UNITED STATES PATENT AND TRADEMARK OFFICE

Final Office  
Action  
10-22-05 (-1 date)

**Office Action Summary**

10/776,872

Drnevich et al. discloses a cryogenic air separation-blast furnace system as shown in Fig 1 below.

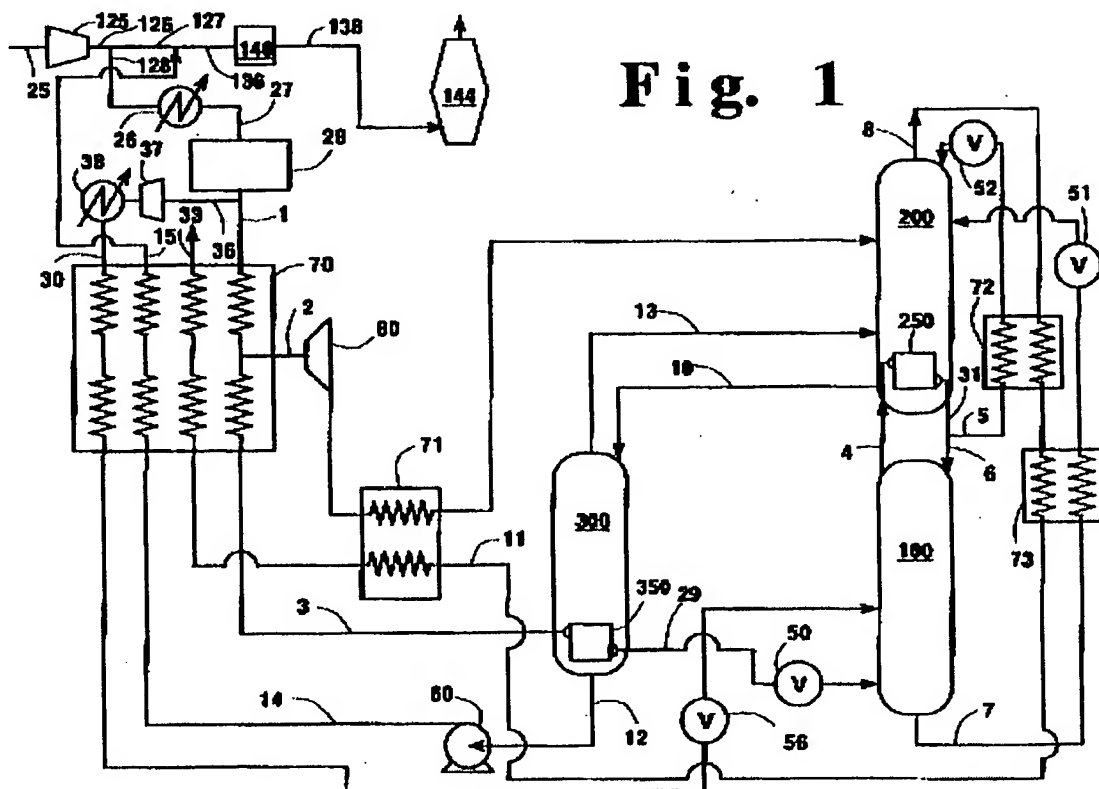
In Drnevich et al., the blast furnace air stream (25) is compressed in a blast air blower (125). A minor portion of the blast furnace feed air stream (126) is taken off (stream 128) as feed to the air separation unit. A primary portion of the blast furnace feed air stream (stream 127) is fed to the blast furnace (144), after being first mixed with the oxygen rich stream (15) returning from the air separation unit. These two streams are combined to form an oxygen-enriched blast air stream (136), which is fed to the blast furnace (col. 4 line 21 to col. 6 line 4).

Drnevich et al. discloses the removal of nitrogen from the upper portion of the separation column (200) as stream 8, warming the nitrogen through heat exchangers 72, 73, 71 and 70, but does not disclose expansion of the nitrogen to recover energy (col. 4 lines 11-20). In a method for air separation combined with a blast furnace, Rathbone (5,268,019) discloses that it is known to be advantageous to recover work from nitrogen produced in cryogenic air separation plants (col. 1, lines 9-28). Rathbone discloses a method for removing a minor portion of the compressed air stream for separation, separating this minor stream into oxygen and nitrogen rich streams, and expanding the nitrogen stream to recover external work (col. 8, line 44-col. 9, line 4).

It would have been obvious to one of ordinary skill in the art at the time the invention was made, to recover work by expanding the nitrogen rich stream generated in Drnevich et al., by any of the means disclosed in Rathbone for heating and expanding the nitrogen to recover work, since Rathbone teaches that it is known to be advantageous to recover work from nitrogen produced in a cryogenic air separation plant (col 1., lines 11-27).
